**CONSULTING ARCHITECT REPORT – Cannon Design Group Recommendations**

*Chirco Drive Residence*  
*Custom One-Story Home*  
*16724 Chirco Dr*  
*Los Gatos, CA 95032*  
*December 9, 2025*

*Staff Technical Review Submittal*  
*Planning Division*  
*Architecture & Site Application S-25-002*  
*Page 12 of 15*

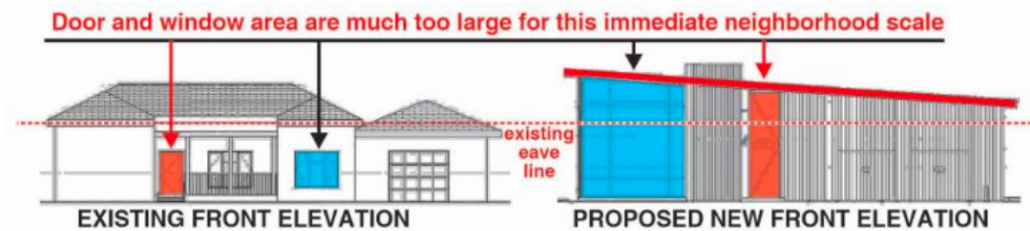
*House immediately across Chirco Drive*

*Nearby house to the right*

*House to the immediate right*

*House to the immediate left*

TMA Looking at the adjacent house roof forms, the project roof has been redesigned from one shed slope to pitched gable – we believe this aligns with the neighborhood while remaining true to the original modern / Eichler aesthetic.

TMA Doors and windows have been redesigned. The front door has been reduced in height to match the adjacent houses, while keeping an open look using sidelites and an upper transom. The windows have been brought down to a 9’ header rather than fully spanning to the roof above, and the overall ratio has been reduced to match the wall-to-opening ratio of our neighbors.

**2.2.2 Provide front facade articulation similar to those predominant in the neighborhood**

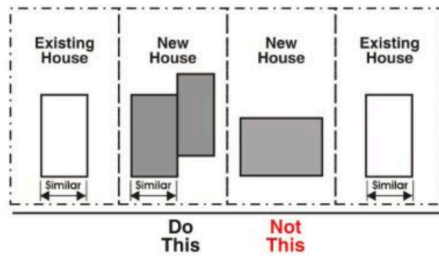
- *If facades along a street front are generally simple, avoid large changes in front wall planes.*
- *Where front wall setbacks are varied in the neighborhood, new homes should relate more to those of adjacent homes.*
- *The width of projecting building masses and the amount of horizontal offsets in wall planes should also be similar.*

TMA The project footprint has been articulated for visual interest and to emulate neighborhood examples.
